Access Compliance Report

Public Rights-of-Way

Intersection ID: 3189	Main Street: SHELLY_PINES_DR	Cross Street: MALLARD_WOODS_PL	Location: SW
ADA ID: B3C3494C1435	Ramp Type: Perp	Initial Pass/Fail: Fail	Overall Compliance: No
		Severity Score: 37.5

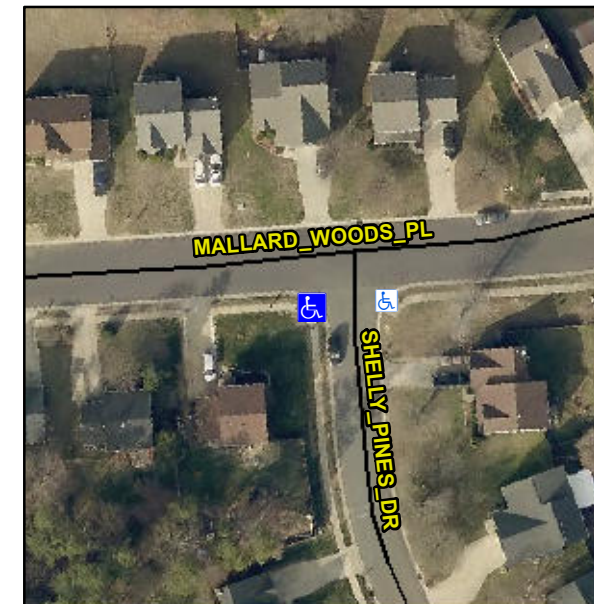
Not Found, R304.2.2, R304.5.3

Compliance	Description	Data	Compliance	Description	Data
N/A	Ramp Length (in)	48.0	No	Ramp Slope (%)	11.6
Yes	Ramp Width (in)	55.0	No	Ramp XSlope (%)	12.3
N/A	Flare Type LT	N/A	N/A	Flare Type RT	N/A
N/A	Flare Slope LT (%)	N/A	N/A	Flare Slope RT (%)	N/A
N/A	Flare Traversable LT?	N/A	N/A	Flare Traversable RT?	N/A
N/A	Landing Length (in)	N/A	N/A	DWS Provided?	N/A
N/A	Landing Width (in)	N/A	N/A	DWS Contrast?	N/A
N/A	Landing Slope (%)	N/A	N/A	DWS Length (in)	N/A
N/A	Landing X Slope (%)	N/A	N/A	DWS Full Width?	N/A
N/A	Landing Curb? (Y/N)	N/A	N/A	DWS Offset (in)	N/A
N/A	Shared Landing?	N/A			
N/A	Gutter Ponding?	N/A	N/A	Gutter Slope (%)	N/A
N/A	Gutter Lip Ht (in)	N/A	N/A	Gutter X Slope (%)	N/A
N/A	Painted X Walk1?	No	N/A	Painted X Walk2?	N/A
	X Walk 1 Direction	To E		X Walk 2 Direction	N/A
N/A	X Walk 1 Width (in)	N/A	N/A	X Walk 2 Width (in)	N/A
	X Walk 1 Slope (%)	4.8		X Walk 2 Slope (%)	N/A
	X Walk 1 X Slope (%)	8.0		X Walk 2 X Slope (%)	N/A

Remove & Replace Entire Ramp.
